Well Name: BIG EDDY UNIT DI 31W 10-7	Well Location: T20S / R31E / SEC 10 / SESW / 32.583273 / -103.858816	County or Parish/State: EDDY / NM
Well Number: 5H	Type of Well: OIL WELL	Allottee or Tribe Name:
Lease Number: NMLC068399	Unit or CA Name: BIG EDDY	Unit or CA Number: NMNM68294X
US Well Number: 3001557367	Operator: XTO PERMIAN OPERATING LLC

Notice of Intent

Procedure Description: Big Eddy Unit DI 31W 10-7 5H US Well Number: 30-015-57367 XTO Permian Operating LLC., encountered unexpected challenges while drilling the Int2 section of this well which led to a decision to plug back & initiate a sidetrack operation. XTO Permian Operating LLC., respectfully requests approval to move forward with the plugging & sidetrack operations. Verbal/email approval was obtained from Zota Stevens, Petroleum Engineer with BLM-Carlsbad on March 21st, 2026, to proceed with our plan. Event summary, current status and proposed plan forward mentioned below for your review - Event Summary During drilling of the Intermediate 2 section at 3,204 ft MD, the rig experienced a power supply failure that resulted in loss of pumping and rotation. After restoring power, the rig crew attempted to pick up and mov

Well bore schematic

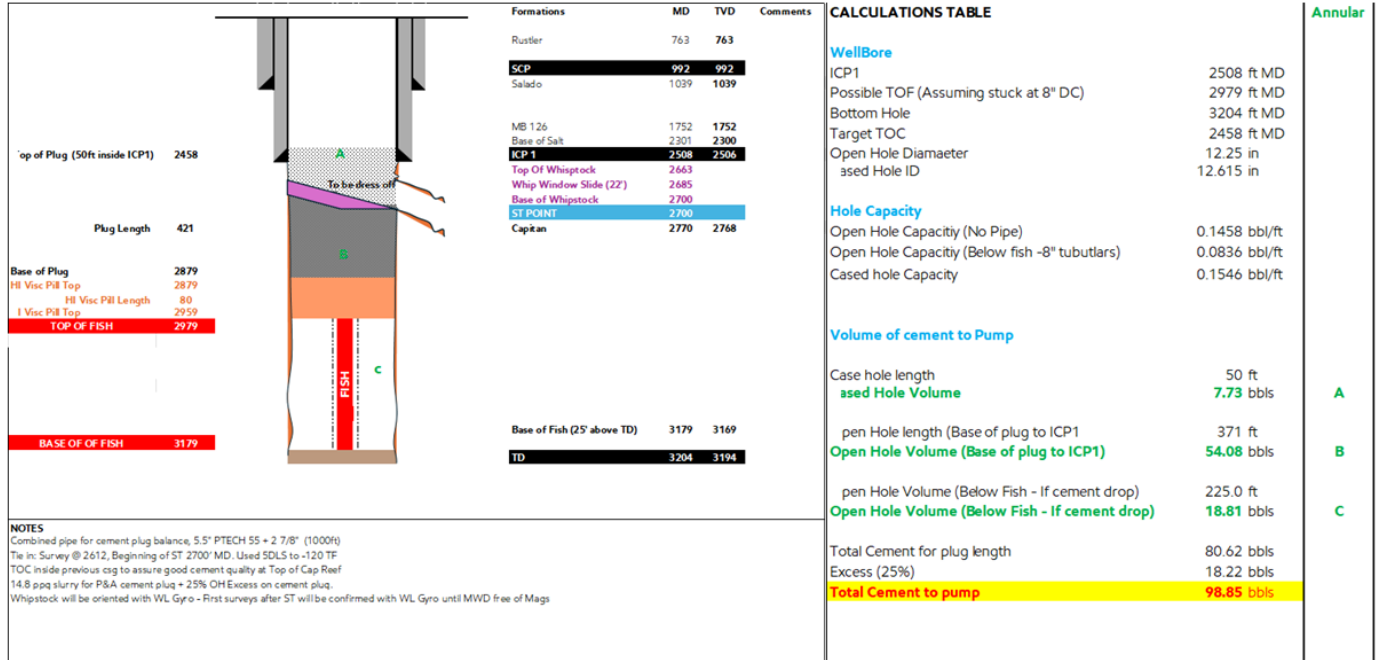
During drilling of the Intermediate 2 section at 3,204 ft MD, the rig experienced a power-supply failure that resulted in loss of pumping and rotation. After restoring power, the rig crew attempted to pick up and move the drill string but were unsuccessful, with the string becoming stuck between approximately 3,180–3,204 ft (bit depth). The well remains stable with no losses or indications of influx. Current operations are focused on recovering and freeing the drill string, working the pipe with jars.

Pump P&A Cement plug + Run OH Whipstock for ST

1. Run combined string (5.5) and balance cement plug (14.8 ppg slurry) from TOF to 50' inside ICP1
2. WOC until get 1000 psi cement CS (~9 hrs)
3. Run Calibration BHA with 2 mill, tag/confirm TOC and dress off to 2700' (Whipstock Depth)
4. Run and orient whipstock, set whipstock according to directional plan
 - i. Tie in: Survey @ 2612, Beginning of ST 2700' MD. Used 5DLS to -120 TF
5. ST with mill assy (2x Bit to bend length)
6. Circulate btm up and TOOH for Conv motor BHA
7. P/U and RIH 1.83°BH and drill rat hole extension until free of Mags
 - i. WL gyro check shots until MWD free of mags
8. Continue drilling to TD

Directional Plan

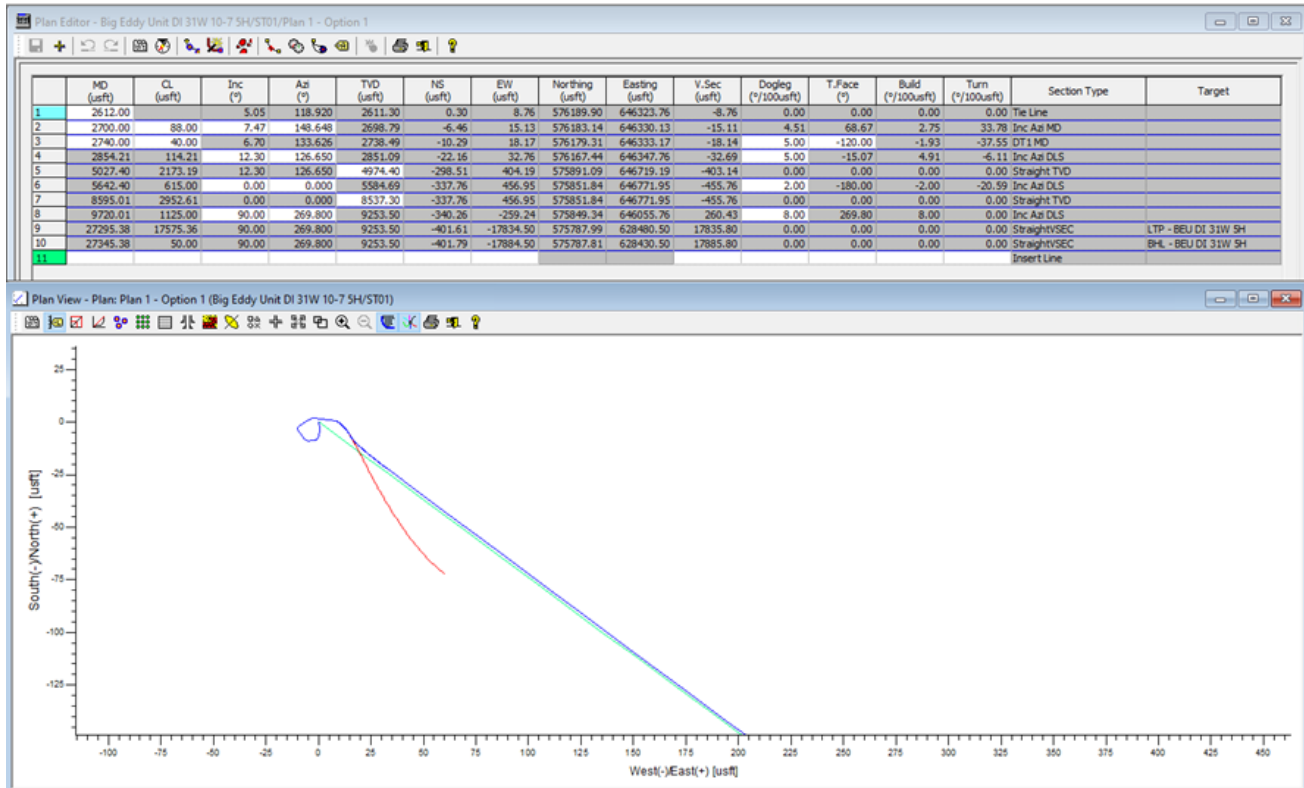
Tie in: Survey @ 2612, Beginning of ST 2700' MD. Used 5DLS to -120 TF

2. Well bore Schematic

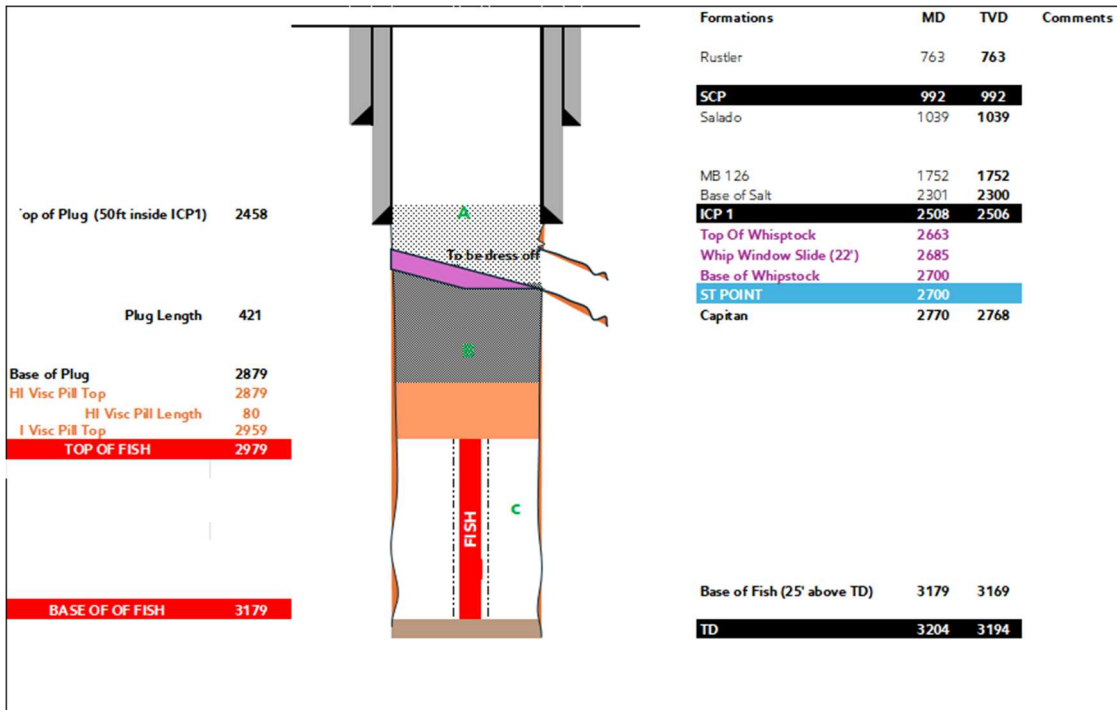
During drilling of the Intermediate 2 section at 3,204 ft MD, the rig experienced a power-supply failure that resulted in loss of pumping and rotation. After restoring power, the rig crew attempted to pick up and move the drill string but were unsuccessful, with the string becoming stuck between approximately 3,180–3,204 ft (bit depth). The well remains stable with no losses or indications of influx. Current operations are focused on recovering and freeing the drill string, working the pipe with jars.

Pump P&A Cement plug + Run OH Whipstock for ST

1. Run combined string (5.5) and balance cement plug (14.8 ppg slurry) from TOF to 50' inside ICP1
2. WOC until get 1000 psi cement CS (~9 hrs)
3. Run Calibration BHA with 2 mill, tag/confirm TOC and dress off to 2700' (Whipstock Depth)
4. Run and orient whipstock, set whipstock according to directional plan
 - i. Tie in: Survey @ 2612, Beginning of ST 2700' MD. Used 5DLS to -120 TF
5. ST with mill assy (2x Bit to bend length)
6. Circulate btm up and TOO H for Conv motor BHA
7. P/U and RIH 1.83°BH and drill rat hole extension until free of Mags
 - i. WL gyro check shots until MWD free of mags
8. Cont drilling to TD.

NOTES
 Combined pipe for cement plug balance, 5.5" PTECH 55 + 2 7/8" (1000ft)
 Tie in: Survey @ 2612, Beginning of ST 2700' MD. Used 5DLS to -120 TF
 TOC inside previous csg to assure good cement quality at Top of Cap Reef
 14.8 ppg slurry for P&A cement plug + 25% OH Excess on cement plug.
 Whipstock will be oriented with WL Gyro - First surveys after ST will be confirmed with WL Gyro until MWD free of Mags

You are approved for this procedure. Submit a NOI sundry with all relevant documents(directional plan, drilling plan(if any casing plan changes from the original AAPD).

4. Directional Plan

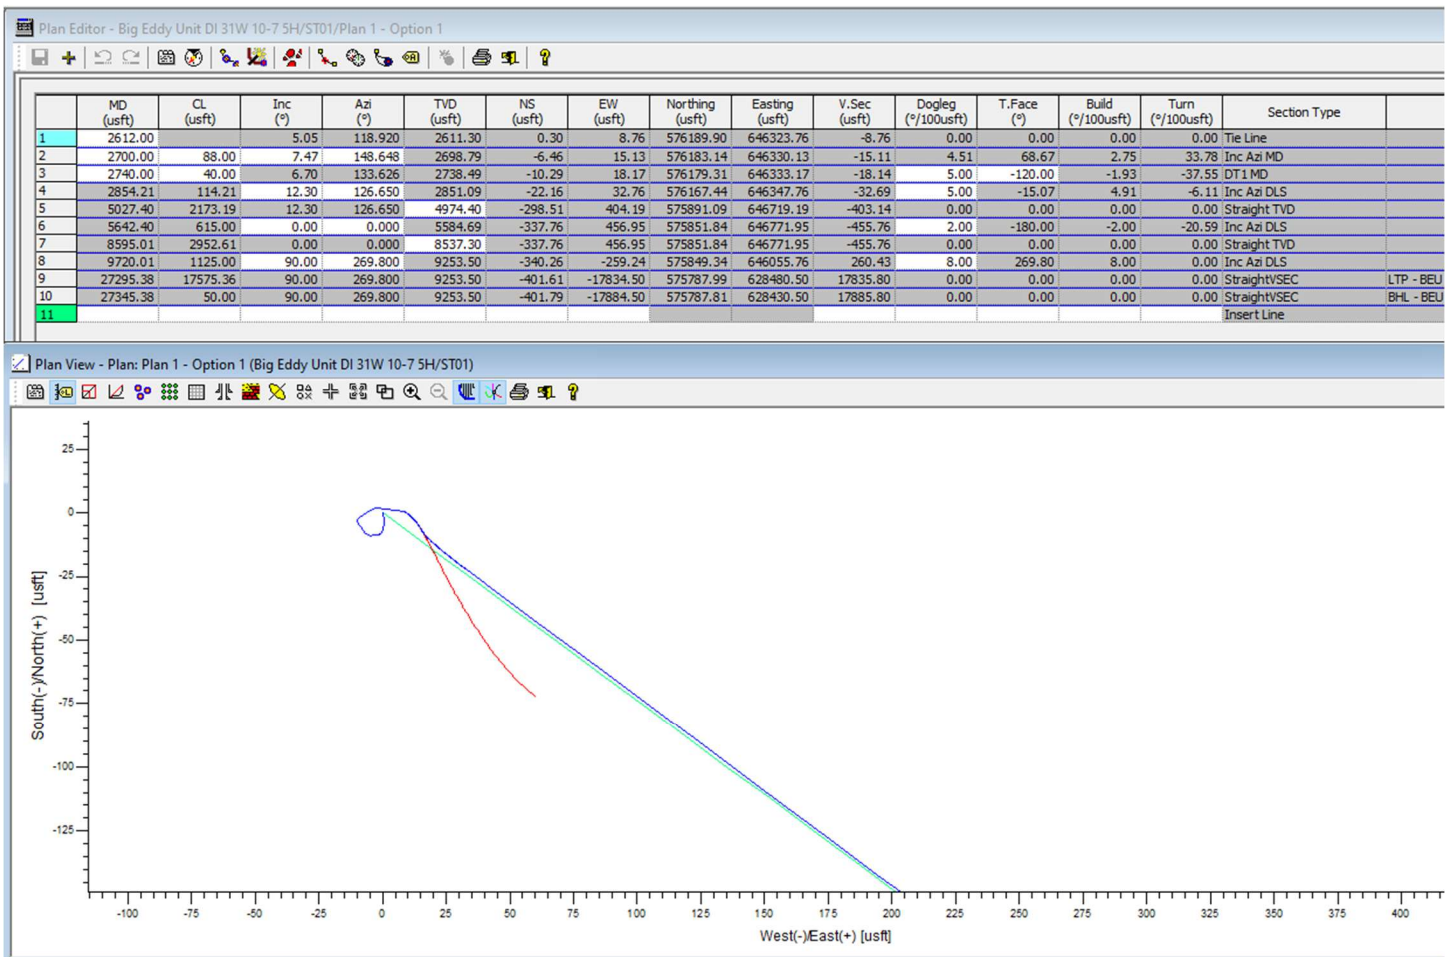
Tie in: Survey @ 2612, Beginning of ST 2700' MD. Used 5DLS to -120 TF

2. Well bore Schematic

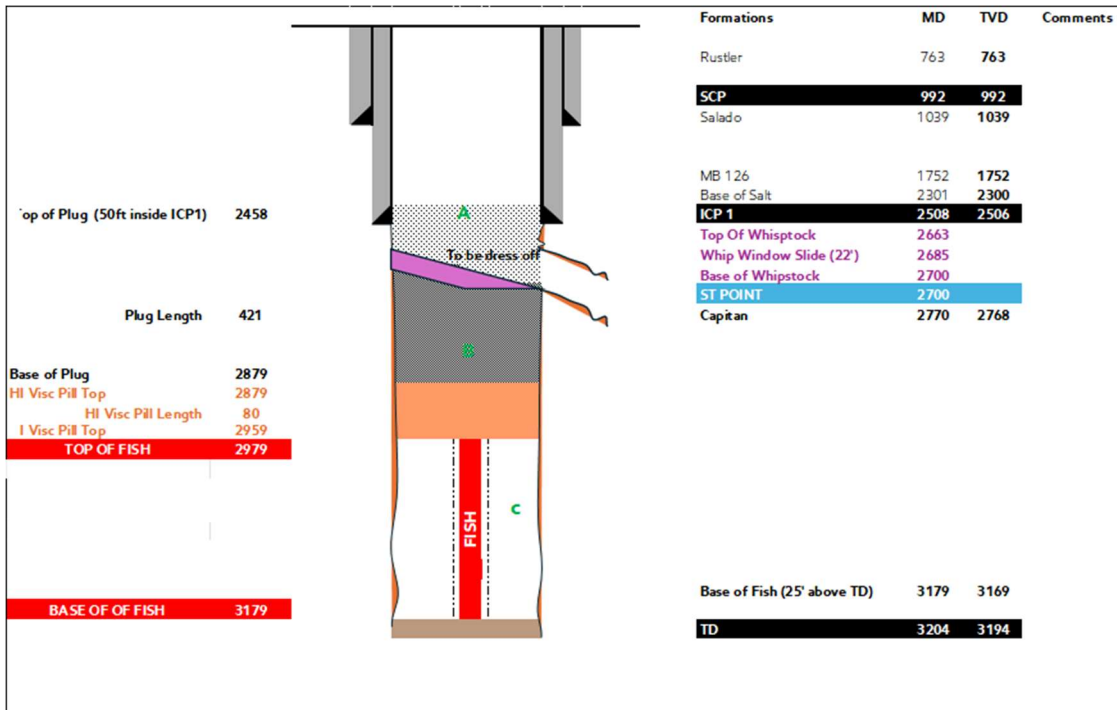
During drilling of the Intermediate 2 section at 3,204 ft MD, the rig experienced a power-supply failure that resulted in loss of pumping and rotation. After restoring power, the rig crew attempted to pick up and move the drill string but were unsuccessful, with the string becoming stuck between approximately 3,180–3,204 ft (bit depth). The well remains stable with no losses or indications of influx. Current operations are focused on recovering and freeing the drill string, working the pipe with jars.

Pump P&A Cement plug + Run OH Whipstock for ST

1. Run combined string (5.5) and balance cement plug (14.8 ppg slurry) from TOF to 50' inside ICP1
2. WOC until get 1000 psi cement CS (~9 hrs)
3. Run Calibration BHA with 2 mill, tag/confirm TOC and dress off to 2700' (Whipstock Depth)
4. Run and orient whipstock, set whipstock according to directional plan
 - i. Tie in: Survey @ 2612, Beginning of ST 2700' MD. Used 5DLS to -120 TF
5. ST with mill assy (2x Bit to bend length)
6. Circulate btm up and TOO H for Conv motor BHA
7. P/U and RIH 1.83°BH and drill rat hole extension until free of Mags
 - i. WL gyro check shots until MWD free of mags
8. Cont drilling to TD.

NOTES
 Combined pipe for cement plug balance, 5.5' PTECH 55 + 2 7/8" (1000ft)
 Tie in: Survey @ 2612, Beginning of ST 2700' MD. Used 5DLS to -120 TF
 TOC inside previous csg to assure good cement quality at Top of Cap Reef
 14.8 ppg slurry for P&A cement plug + 25% OH Excess on cement plug.
 Whipstock will be oriented with WL Gyro - First surveys after ST will be confirmed with WL Gyro until MWD free of Mags

You are approved for this procedure. Submit a NOI sundry with all relevant documents(directional plan, drilling plan(if any casing plan changes from the original AAPD).

4. Directional Plan

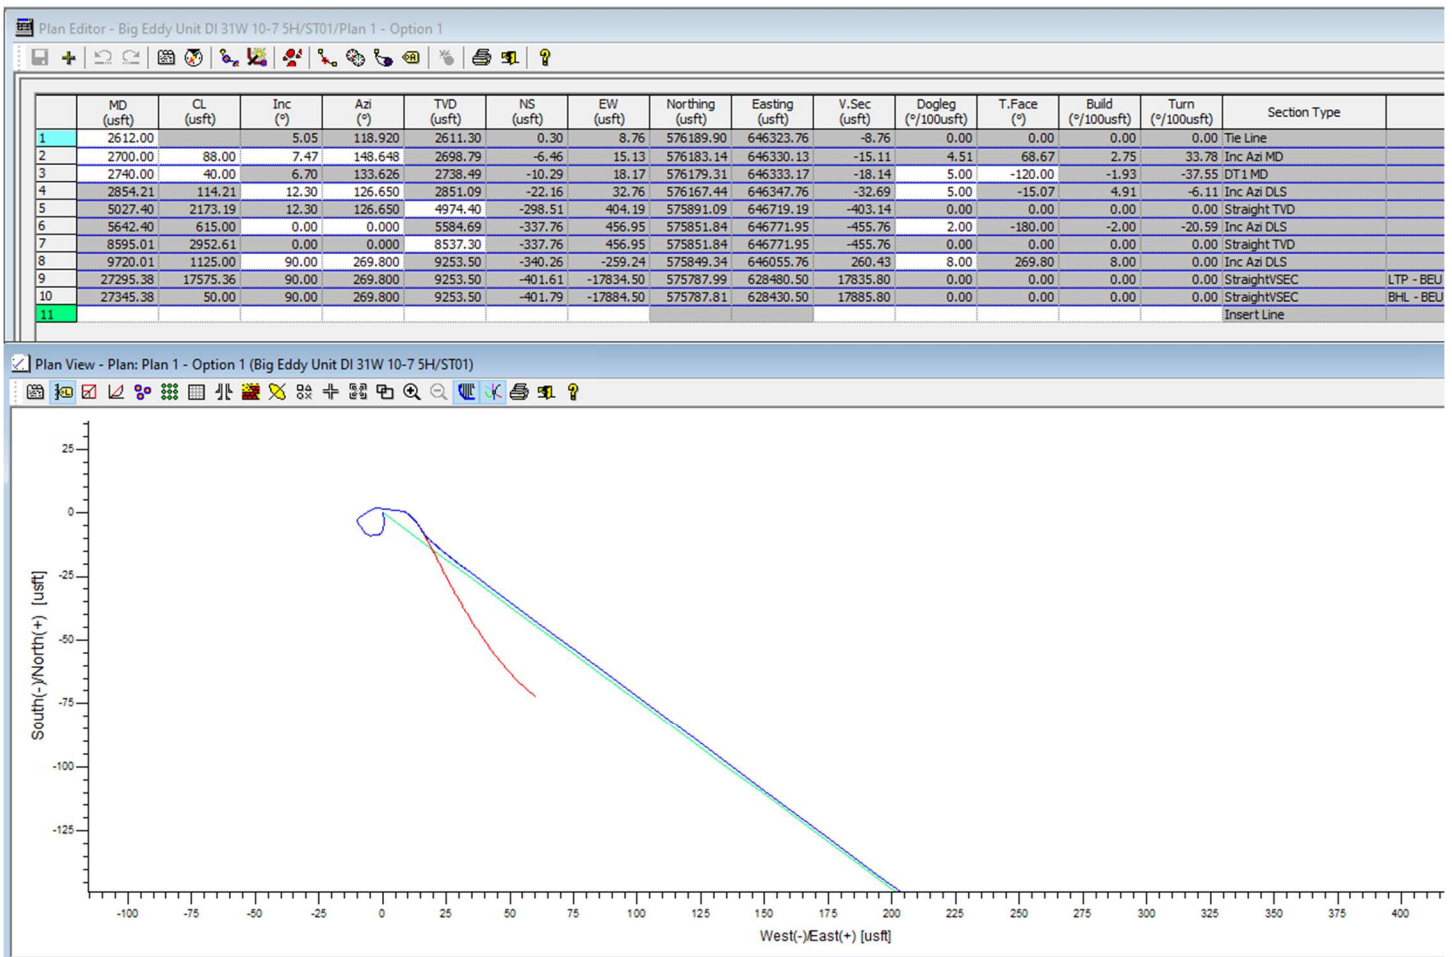
Tie in: Survey @ 2612, Beginning of ST 2700' MD. Used 5DLS to -120 TF

Created By	Condition	Condition Date
ward.rikala	Operator is to sidetrack around the fish and then get back on the original approved directional plan for this well.	4/2/2026
ward.rikala	If unable to get back on approved directional plan, a C-103 NOI must be submitted for approval with new C-102 showing new trajectory identifying FTP and LTP for the new BHL.	4/2/2026
ward.rikala	Any previous COA's not addressed within the updated COA's still apply.	4/2/2026
